Addendum 05

PROJECT: Fort Loramie Local Schools Athletic Complex Building & Associated Improvements
600 East Park Street
Fort Loramie, Ohio 45845

PROJECT #: 25041.00

This addendum form is a part of the Contract Documents and modifies the Bidding Documents dated December 11, 2025 with amendments and additions noted below.

1 / E4.1 **FIRST FLOOR LIGHTING PLAN**
1/8" = 1'-0"

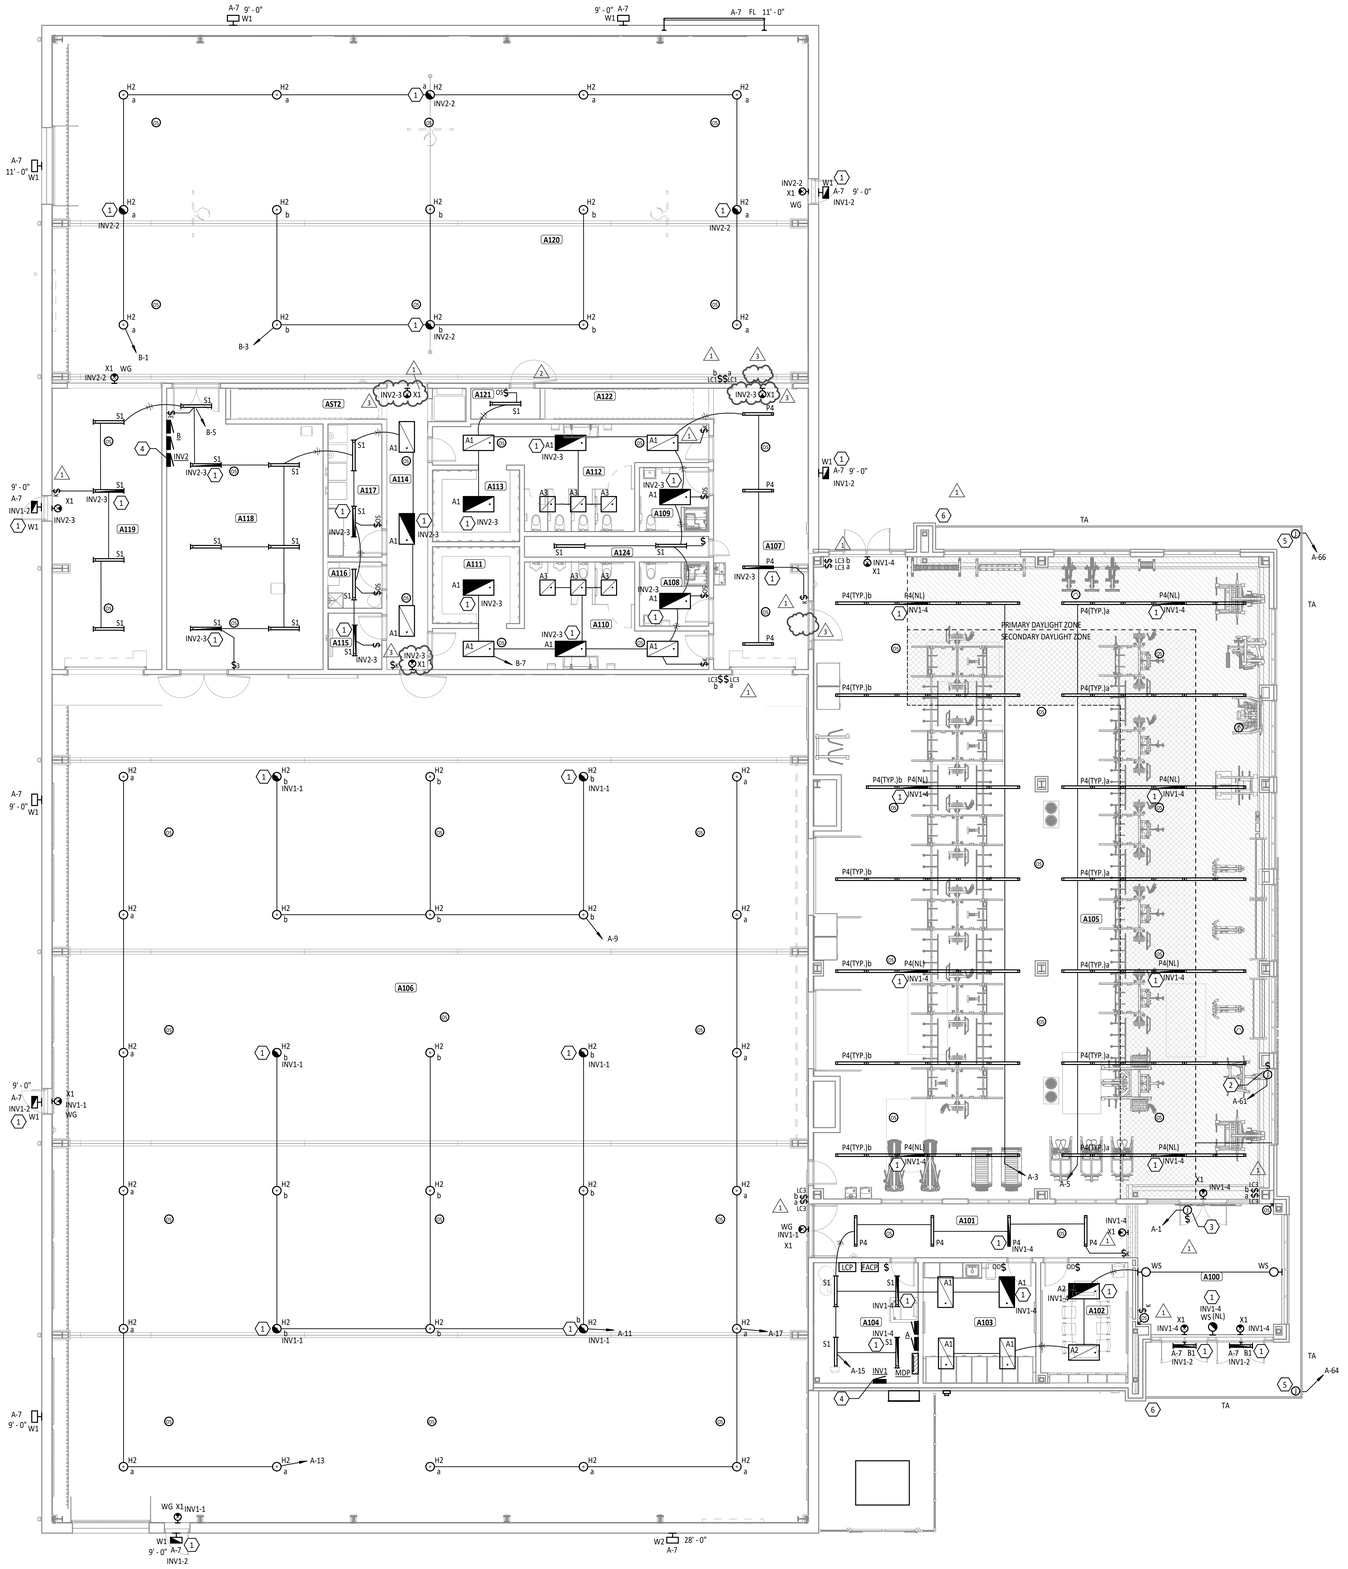
16. Sheet E4.1 – First Floor Lighting Plan
    a. Removed exit sign from A107 (not a path of egress).
    b. Added exit sign in A107 (correct path of egress).

c. Removed exit sign in A120 (not a path of egress).
    d. Added 2 exit signs in A114.
17. Sheet E5.1 – First Floor Power Plan
    a. Removed dead face GFCI (already protected by GFCI circuit breaker in A105.

1 FP1.1 **FIRST FLOOR FIRE PROTECTION PLAN**
1/16" = 1'-0"

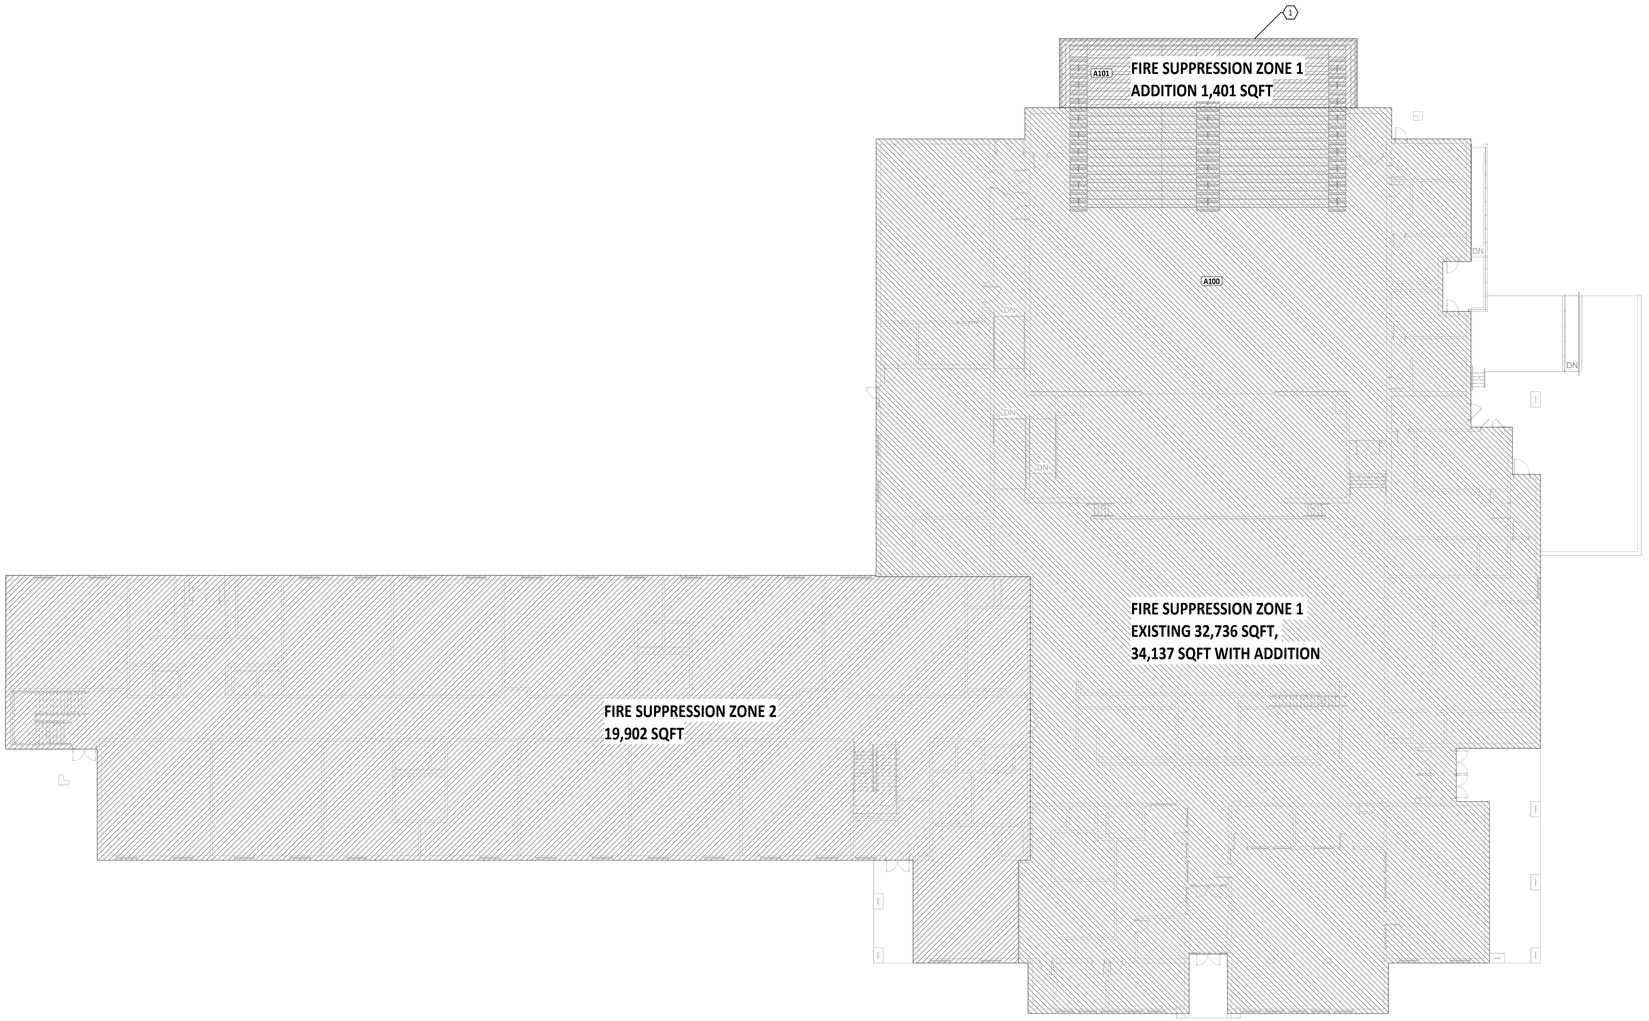
1. Sheet G0.1 – Cover Sheet
   a. Add Sheet FP1.1
2. Sheet FP1.1 – Fire Protection Plan:
   a. New sheet showing extension of sprinkler layout to cover the new addition.

SITE PLAN AND DETAILS

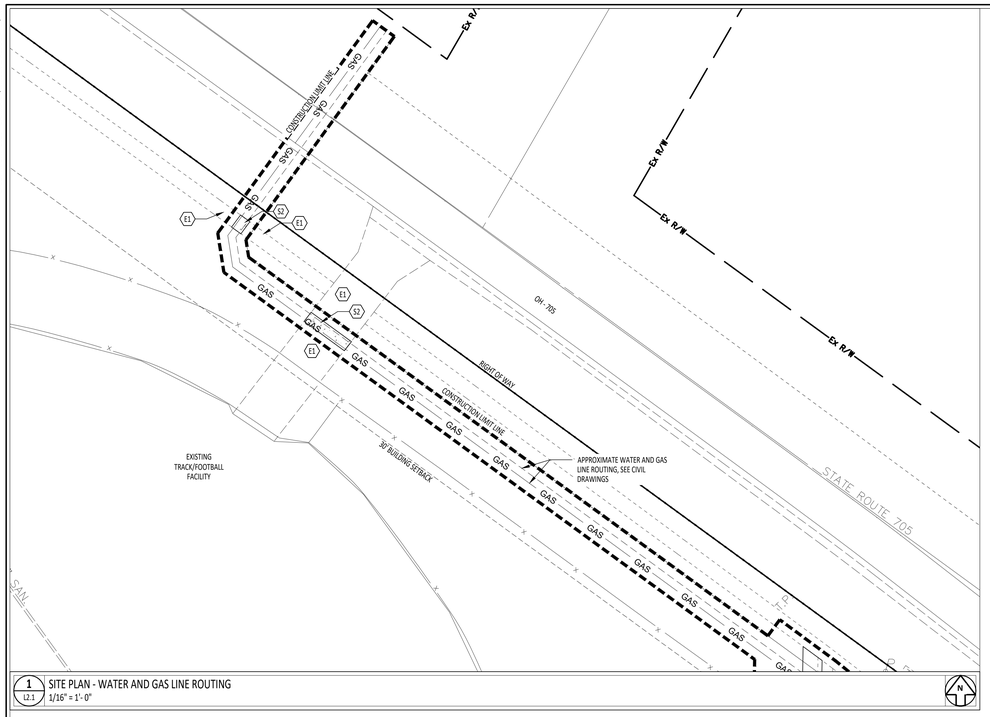
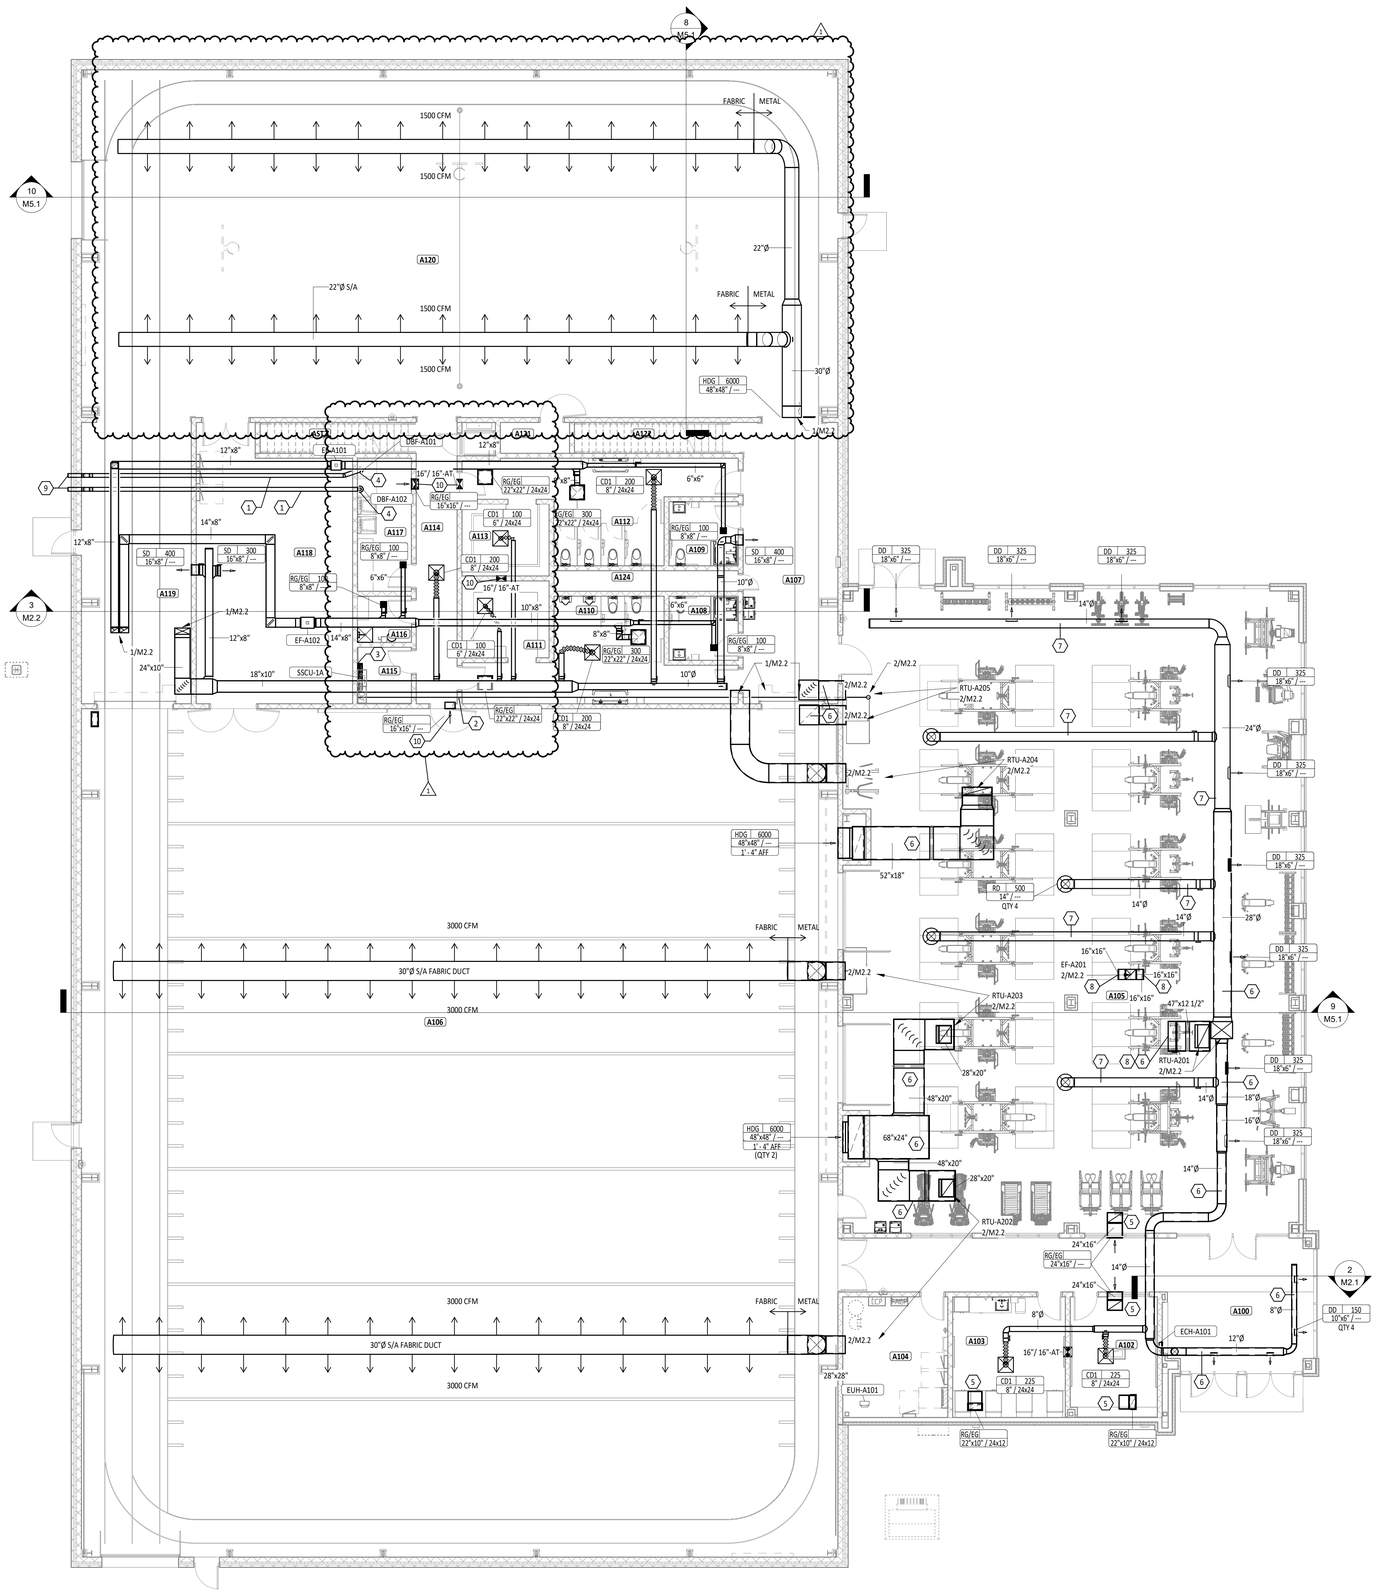
a. Alternate 07 site furnishing details have been added. Locations to be determined by owner.
3. Sheet A0.2 – Wall Types/Mounting Height
   a. Added furring to walls with liner panel and metal stud.

12. Alternate #07 is to provide Site Furnishings. There is not site furnishings spec or location designations on the drawings. Please advise.
    a. **Response: L2.1 updated in Addendum 05**

1 / M2.2 MEZZANINE MECHANICAL PLAN
1/8" = 1'-0"

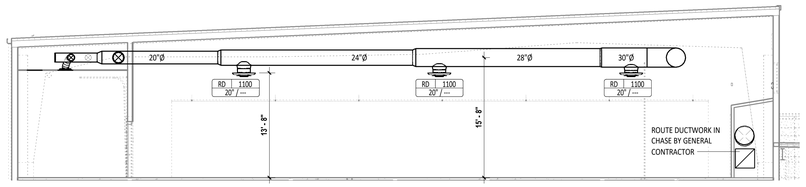
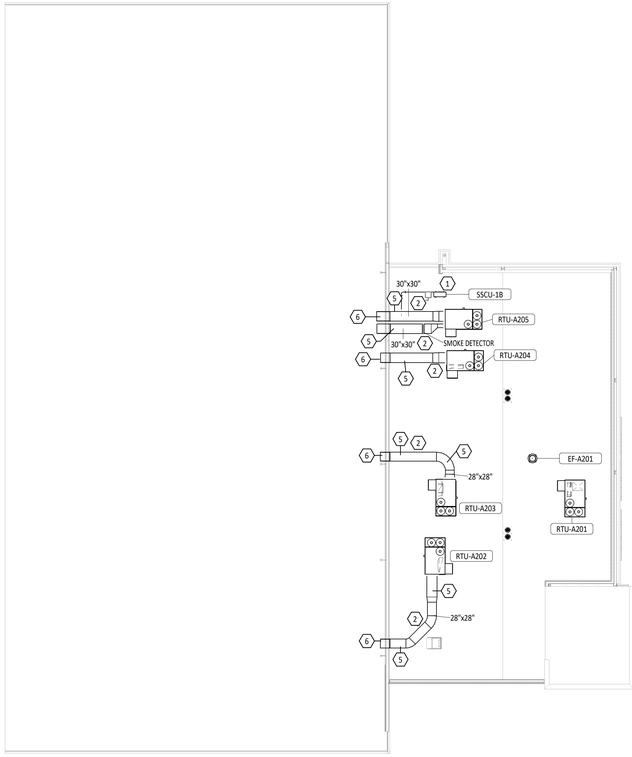
a. Add air transfer openings and grilles as shown on updated sheet.
    b. Add Keynote #7.
    c. Modify supply airflow value for RTU-A204 as shown on updated sheet.

10 MS.1 AUXILLARY GYMNASIUM SECTION - #2
1/8" = 1'-0"

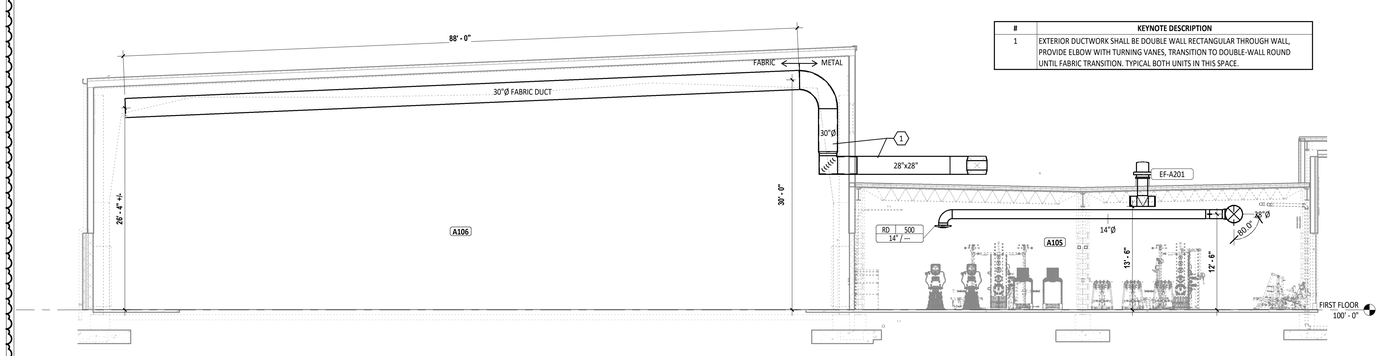
12. Sheet M5.1 – Mechanical Details
    a. Update detail 2/M5.1.
    b. Update section view 8/M5.1.
    c. Add new section view 10/M5.1.
13. Sheet E1.2 – Electrical Details

1 P2.1 **UNDER-SLAB PLUMBING PLAN - UNIT A**
1/8" = 1'-0"

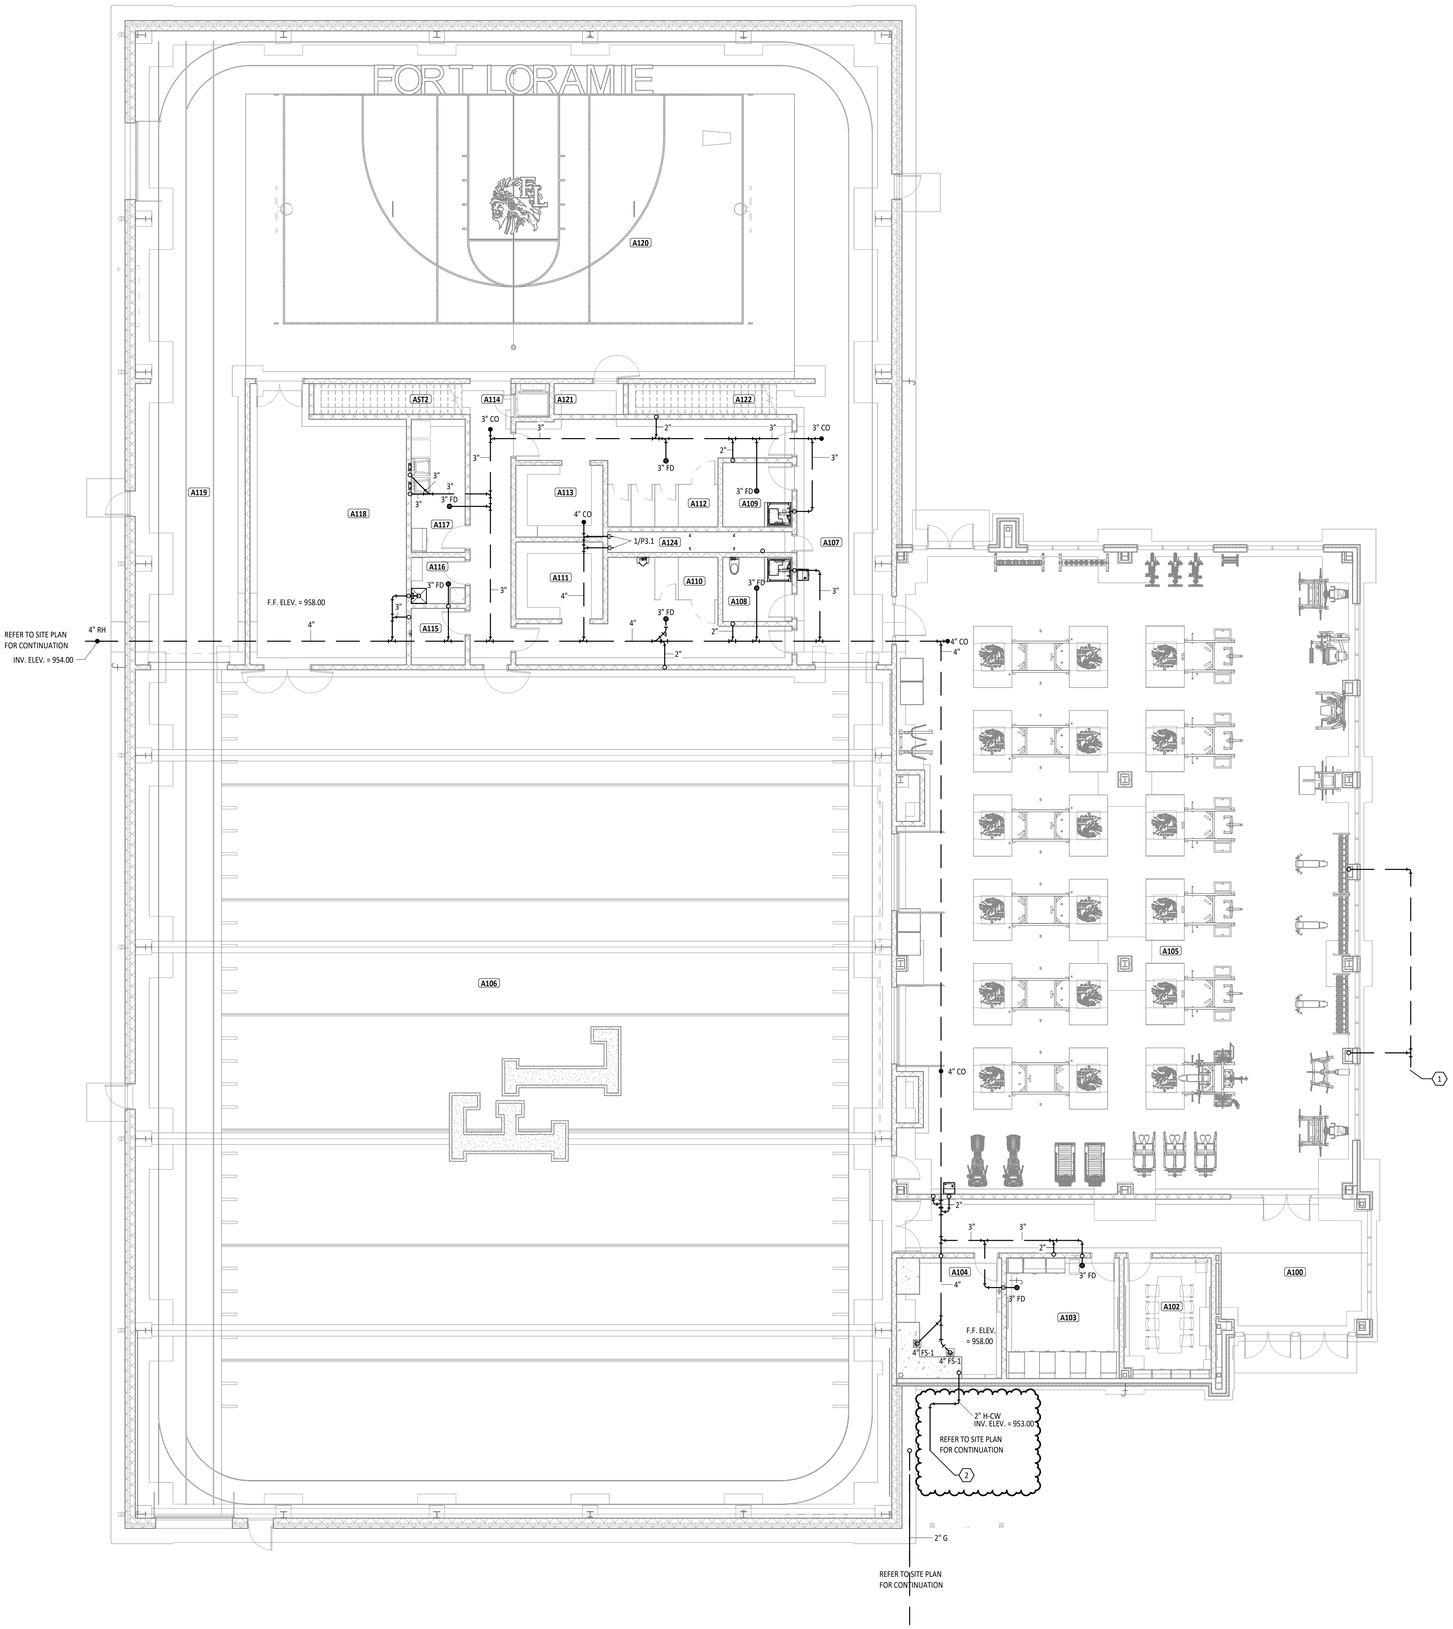
8. Sheet S1.1 – Foundation Plan
    a. Added slab-on-grade along grids 1 and B
9. Sheet P2.1 – Under -Slab Plumbing Plan – Unit A:
    a. Added keynote # 2 – "ROUTE WATER MAIN TO AVOID RUNNING UNDER ELECTRICAL TRANSFORMER. COORDINATE WITH ELECTRICAL AND SITE CONTRACTORS."

10 T1.3 **LARGE VENUE PROJECTOR OUTLET (LVP)**

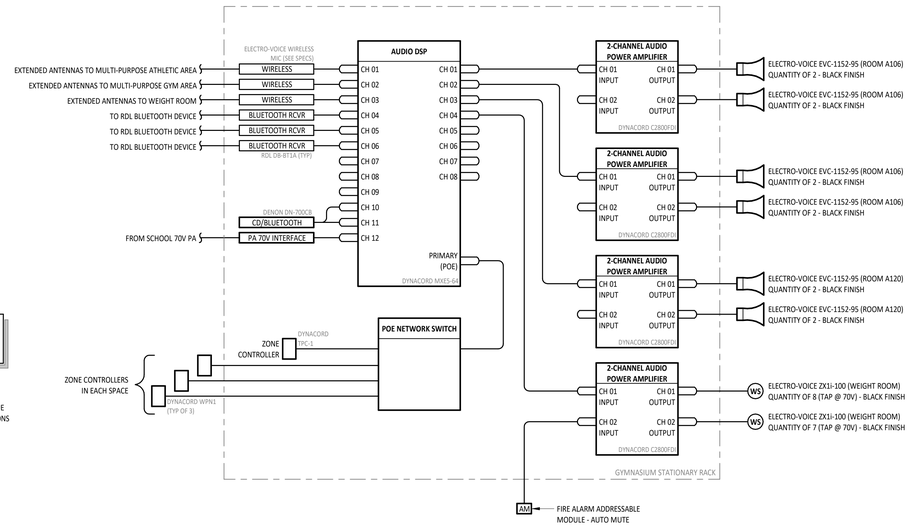
20. Sheet T1.3 – Technology Details
    a. Changed cable type from Cat6 to Cat6a
21. Sheet TC1.1 – First Floor Technology Cabling Plan
    a. Additional keynote to clarify speaker types

5. Faceplate details indicate using Cat 6A cabling except for the "LI" and "LVP" detail. those two are calling for Cat 6. Please clarify.
    a. **Response: Cat6a cabling is required. Sheet T1.3 has been updated and included with Addendum 05.**
